FURTHER OBJECTION TO DEVELOPMENT PROPOSALS MP_07 0166 MOD 8

MP07_0166 Mod 8 is an application seeking to modify the Wahroonga Estate Concept Plan by providing detailed amended residential building envelopes and amended residential car parking rates for Precinct B: Central Church Precinct. The modification does not seek to alter the total maximum dwellings approved under the existing Concept Plan.

indicative solar access diagram

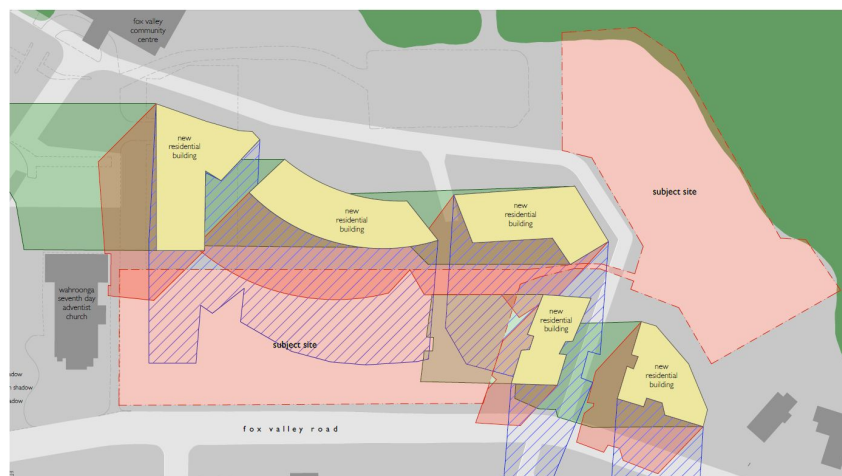
Whilst the amended plans, have amended the location of the building envelopes slightly, it can be seen from the above diagram that a large proportion of the school site will remain in shadow. Accordingly, it is considered that the concerns remain valid and the proposal will result in negative adverse impacts on the adjacent school site. The proposed Mod 8 application to increase the height planes and height limits of the buildings should not be approved and the detailed floor plans should also not be approved for the above reasons.
